AGENDA
DEVELOPMENT IMPACT FEE ADVISORY COMMITTEE
Monday, June 15, 2020
Hailey City Hall
4:30 p.m. (before P & Z regular meeting)

MEMORANDUM

To: Hailey Development Impact Fee Advisory Committee and Hailey City Council
From: Heather Dawson, Administrator
Brian Yeager, Engineer
Date: June 15, 2020
RE: Report and Recommendations on FY 2021 Capital Budget and Capital Improvement Plan

Agenda
HAILEY PLANNING & ZONING COMMISSION
Monday, June 15, 2020
Virtual Meeting
5:30 p.m.

L1

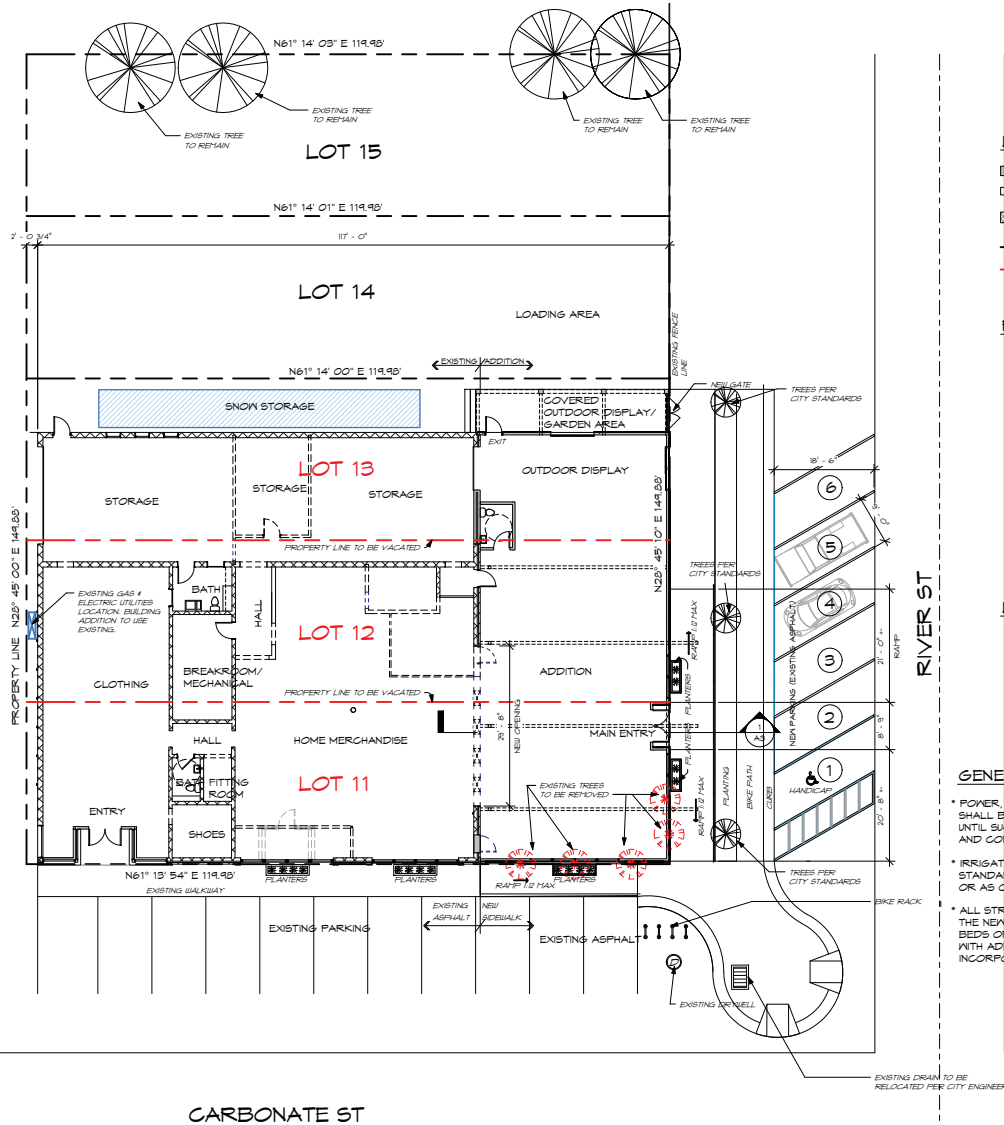
<input checked="" type="checkbox"/>	<input type="checkbox"/>	<input type="checkbox"/>	17.06.080(A) 1b	b. All existing plant material shall be inventoried and delineated, to scale, and noted whether it is to be preserved, relocated or removed. Removal of trees larger than 6-inch caliper proposed to be removed require an arborist review. Any tree destroyed or mortally injured after previously being identified to be preserved, or removed without authorization, shall be replaced with a species of tree found in the Tree Guide and shall be a minimum of 4-inch caliper.
			<i>Staff Comments</i>	<i>Several medium-sized deciduous trees, will be removed as a part of the proposed project, including two small trees within the city right-of-way. Because the applicant is proposing new improved street frontage on all sides of the proposed project, replacing the trees on the property is not feasible, however, as a part of improvement requirements along River Street, the applicant will be required to install street trees. Tree committee review of the city trees to be removed will be required and has been added as a condition of approval.</i>

1 BUILDING SECTION
3/8" = 1'-0"

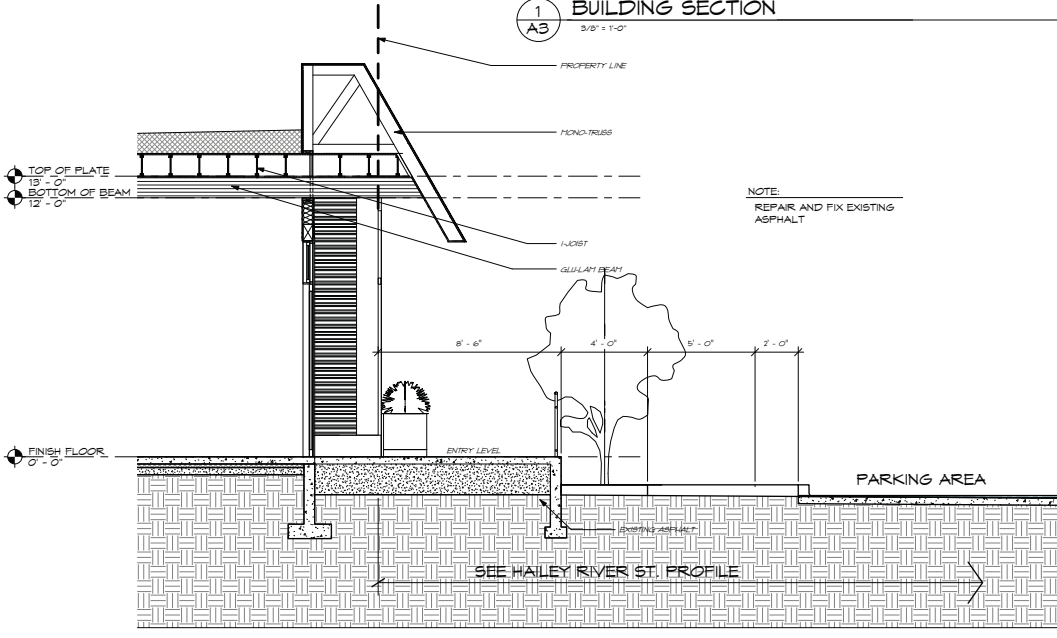
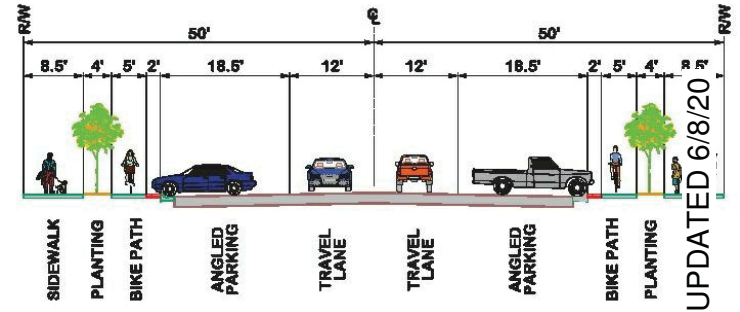
Staff Comments	<i>The applicant is proposing to complete the Carbonate Street sidewalk at its current 6' width and improve the River Street right-of-way to meet city standards set by the River Street cross section detail including a bike lane, 10' sidewalk, street trees, and diagonal parking. The Commission is encouraged to discuss the extent to which improvements are necessary for an addition versus new construction.</i> <i>Due to the grade change on the site and at the edge of the property in relation to the centerline of River Street, there are substantial grading issues with the River Street improvements. The applicant has proposed to build a ramped sidewalk to create ADA accessibility to the new River Street main entry, which may pose future grade issues in the completion of River Street right-of-way improvements. Staff is currently working through options to manage this issue and will be in attendance at the June 15, 2020 hearing to address the topic and answer any questions the Commissioners may have.</i>

Staff Comments	<i>N/A No retaining walls are planned per se, although the elevated sidewalk along River Street necessary to accommodate grade will require a guard rail.</i>
<input type="checkbox"/>	<input type="checkbox"/>	<input checked="" type="checkbox"/>	17.06.080(A) 4j	j. Retaining walls shall be constructed of materials that are utilized elsewhere on the site, or of natural or decorative materials.
			Staff Comments	<i>N/A No retaining walls are planned.</i>
<input type="checkbox"/>	<input type="checkbox"/>	<input checked="" type="checkbox"/>	17.06.080(A) 4k	k. Retaining walls, where visible to the public and/or to residents or employees of the project, shall be no higher than four feet or terraced with a three-foot horizontal separation of walls.
			Staff Comments	<i>N/A No retaining walls are planned.</i>
<input type="checkbox"/>	<input type="checkbox"/>	<input checked="" type="checkbox"/>	17.06.080(A) 4l	l. Landscaping should be provided within or in front of extensive retaining walls.

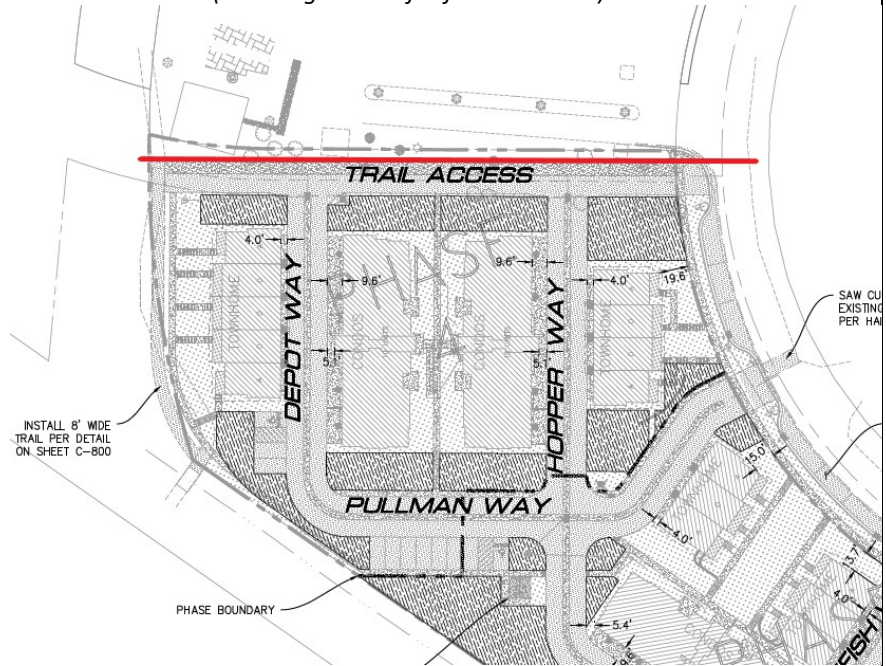
<i>Staff Comments</i>	<i>A new five (5’) foot-wide sidewalk is proposed along the perimeter of the proposed project. This sidewalk will run parallel to Shenandoah Drive,</i>

approximately 600' in length, before curving to the east and crossing Shenandoah Drive (continental crosswalk, which utilizes thermoplastic materials). This sidewalk will connect to existing pathways found near and around the park space and amenity building.

Pedestrian connections are also shown at the northwestern end of the parcel, connecting to the Wood River Trail, and from the Wood River Trail to Shenandoah Drive (see image below for further details).

A second connection is also proposed from the public sidewalk on the north side of Countryside Boulevard to the Wood River Trail (see image below for further details).
